## Regular Council Meeting

<b>To:</b>	Mayor and Council
<b>Date:</b>	April 20, 2020
<b>From:</b>	Karen Ellis, Director of Planning
<b>Report Number:</b>	Planning 2020-06
<b>Subject:</b>	5 King Street East Millbrook – Proposed Renovation and Addition

# Attachment No. 5: North and West Elevations

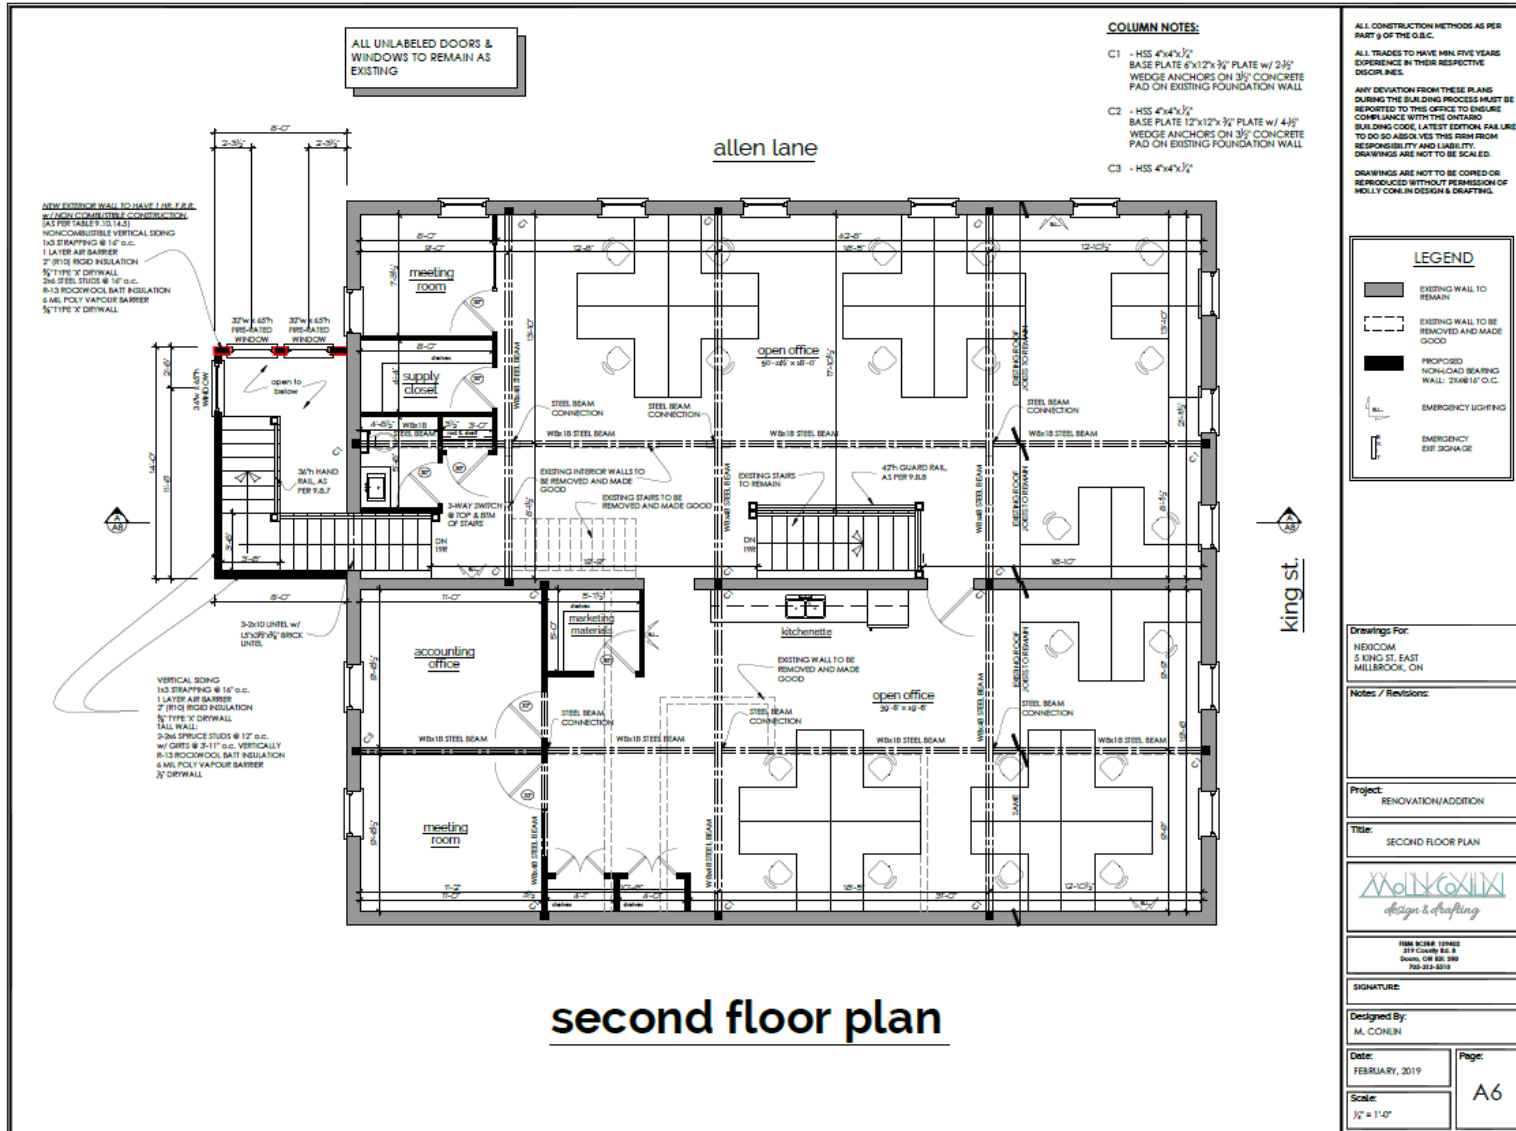
1. Can the materials used in the addition match the King Street addition - i.e. colour, board and batten siding, etc.?
2. How will the porch be finished? Is the 6 x 6 to be left natural, stained, painted?
3. Can sills be added to the windows in the addition to tie into the pattern language of the principal elevation?
4. Can the pattern language of the original windows be maintained? The drawing indicates that the new windows are just slightly larger than the existing windows.
5. Can the new windows match the existing masonry openings?
6. Can the porch fascia along west elevation align with some heritage element to give it reasoning and tie back to the original structure?
7. Does the brick dentil detailing course continue along the south elevation? If so, can the top of the roof be dropped ever so slightly so the detailing is not lost/interrupted?

1. The materials used in the addition will match the King Street addition;
2. The porch will be stained or painted with similar colours to that which are already used on the building;

3. Window sills will be added to the addition;
4. The pattern language of the original windows will be maintained;
5. The new windows will match the existing masonry openings by ensuring that they align with the top and bottom of the existing windows. The existing proportions will be maintained;
6. The porch fascia along west elevation will align with a heritage element to give it a reasoning and tie back to the original structure; and
7. The drawings have been revised to address the brick dentil course.

Nexicom Staff followed up their answers to the questions with the submission of revised plans. A copy of those plans is provided as Attachment Nos. 3 to 6 to this Report. The revised plans were circulated to members of the MRHAC via email.
